Groundwater Transfer Review Summary Form

Transfer/PA # T- 13391

Application: T-13391

Applicant Name: City of Redmond

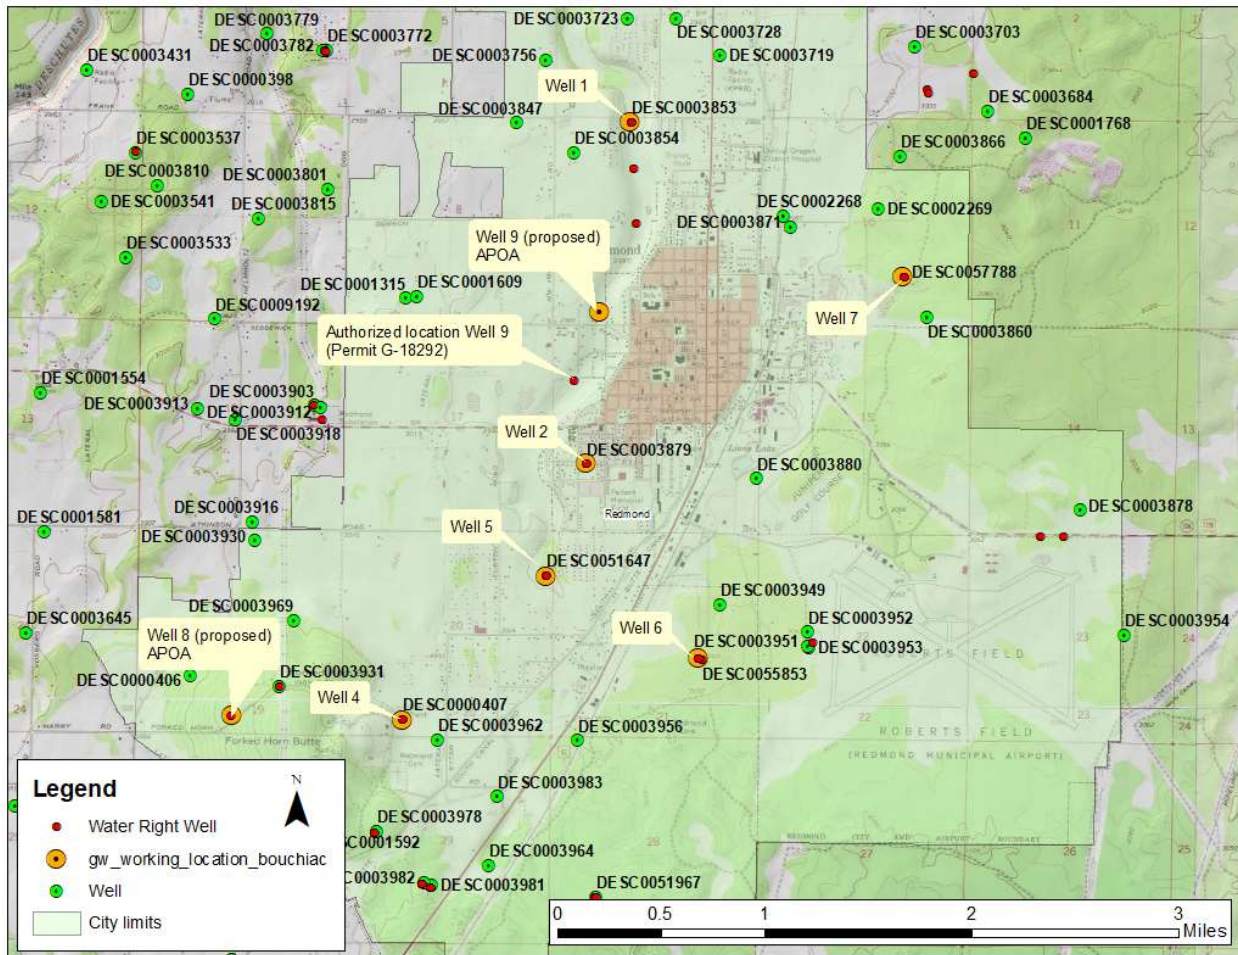
1. Basic description of the changes proposed in this transfer: This application proposes adding two additional points of appropriation (Well 8 and Well 9) to water right Certificates 87796, 89448, 89447 and 89415.

A recent transfer (T-13114, groundwater review dated 5/3/2019) amended the location of proposed Well 8 under application G-14908. The amended location was approved and Well 8, at the new location, is authorized under Permit G-18292. The location of Well 8 in this transfer (T-13391) matches the location in Permit G-18292. No amendments were made to the location for proposed Well 9 under transfer T-13114. **Please note, the authorized location for proposed Well 9 under Permit G-18292 does not match the proposed location for Well 9 under this transfer (T-13391).**
